**STATE OF DELAWARE
EXECUTIVE DEPARTMENT
OFFICE OF STATE PLANNING COORDINATION**

RE: PLUS review 2015-03-02, The Village Center

Thank you for meeting with State agency planners on March 25, 2015 to discuss the proposed plans for The Village Center. According to the information received, you are seeking review of a rezoning of 33.2 acres from AR-1 to CR-1 and a site plan for 203,000 square feet of commercial space located to the southeast of the intersection of Kings Highway and Gills Neck Road in Sussex County.

Figure 1: NRCS soil survey mapping update in the immediate vicinity of the proposed construction

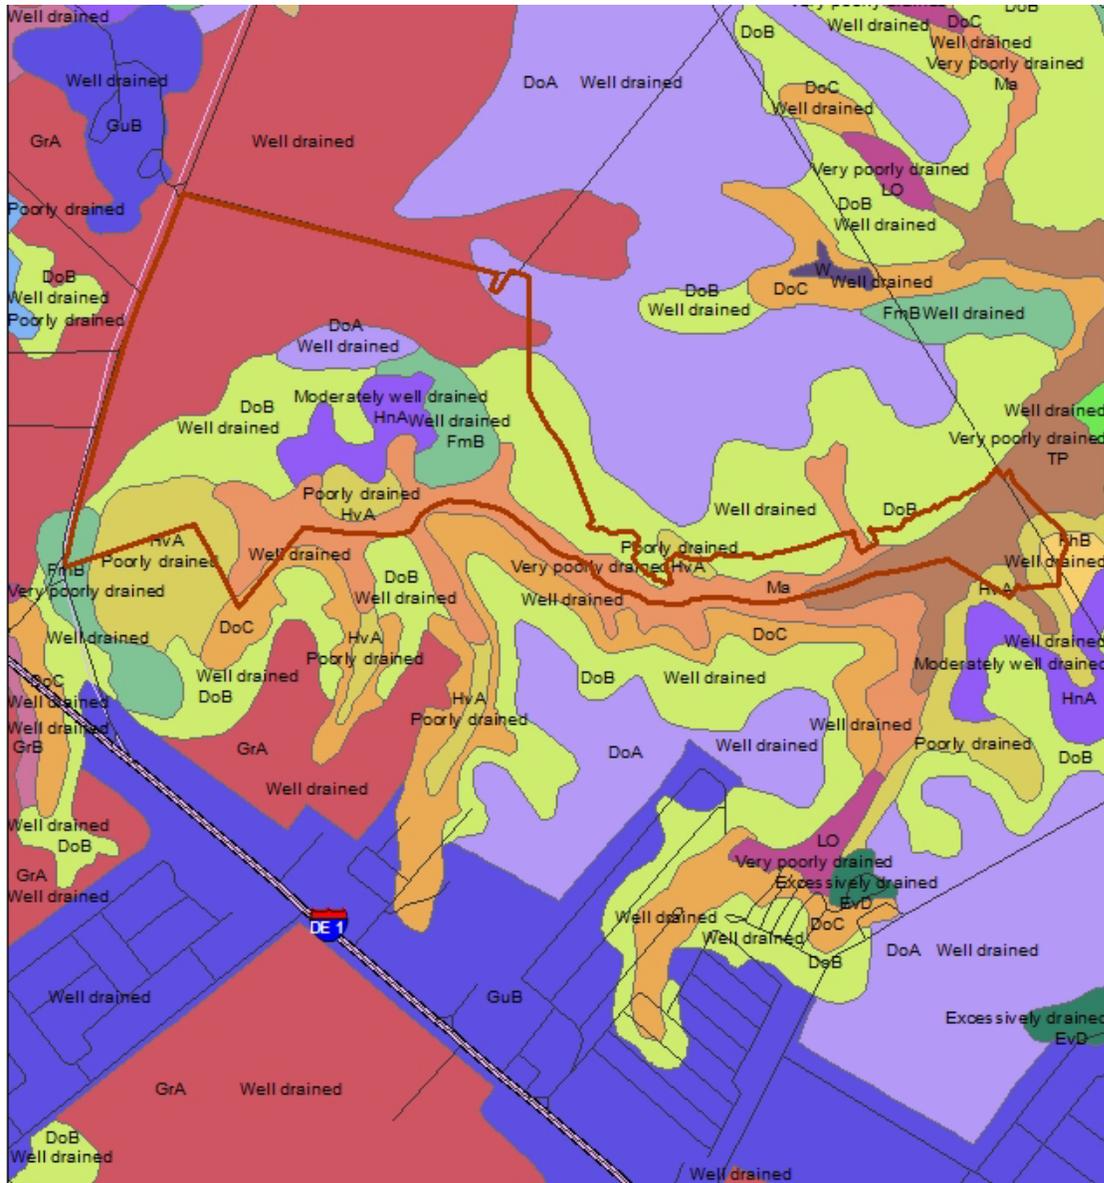
- Based on soils survey mapping update, the soil mapping units with the most limitations for development are Hurlock (HvA), Manahawkin (Ma), Hurlock, and Transquaking & Mispillion (TP). These soil mapping units are poorly to very poorly drained wetland associated (hydric) soils that are considered to have severe limitations for development (considered unsuitable). Therefore, DNREC strongly recommends that the applicant avoid development in all hydric soil mapping units. (Figure 1).
